Process Sheet

Customer : CU-DAR001 Dart Helicopters Services	Drawing Name : PLUG
Job Number : 47472	
Estimate Number : 12322	
P.O. Number :	Part Number : D34921
This Issue : 24/04/2009 S.O. No. :	Drawing Number : D3492 REV C
Prsht Rev. : NC	Project Number : N/A
First Issue : / / Type : MACHINED PARTS	Drawing Revision : C
Previous Run : 46692	Material :
Written By :	Due Date : 30/04/2009 Qty: 60 Um: Each
Checked & Approved By : <u>30009.04.24</u>	
Comment : : est rev A 06.03.03 New Issue EC Est Rev:B 06-08-28 As per Rev B JLM Est Rev:C 07-12-06 Rev C dwg DD verified by:EC Est Rev:D 09-02-18 remove o'ring DD Est Rev:E 09-03-07 Removed Small Fab Dedurr JLM Verified By:EC

Drawing Name: PLUG

DRAWING NO. D3492	TITLE PLUG	REV. C	DART AEROSPACE LTD ENGINEERING ORDER		D.E.O. NO. D3492-C-1	SHEET NO. SHEET 1 OF 1	SCALE NTS
DRAWN AJS	CHECKED	MFG. APPR. <i>B</i>	APPROVED <i>MP</i>	DE APPR. <i>MP</i>			
DATE 08.11.05	DATE 08.11.05	DATE 08.11.05	DATE 08/11/05	DATE 08/11/05

D3492-XX PLUG

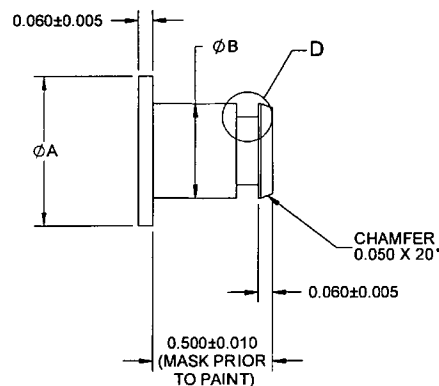
SHEET 2 MODIFY -13 PLUG AS SHOWN:

WAS:

P/N	A	B	C	MATERIAL SPEC
D3492-13	0.750	0.520	0.045	M6061T6R0.750

IS:

P/N	A	B	C	MATERIAL SPEC
D3492-13	0.750	0.510	0.045	M6061T6R0.750
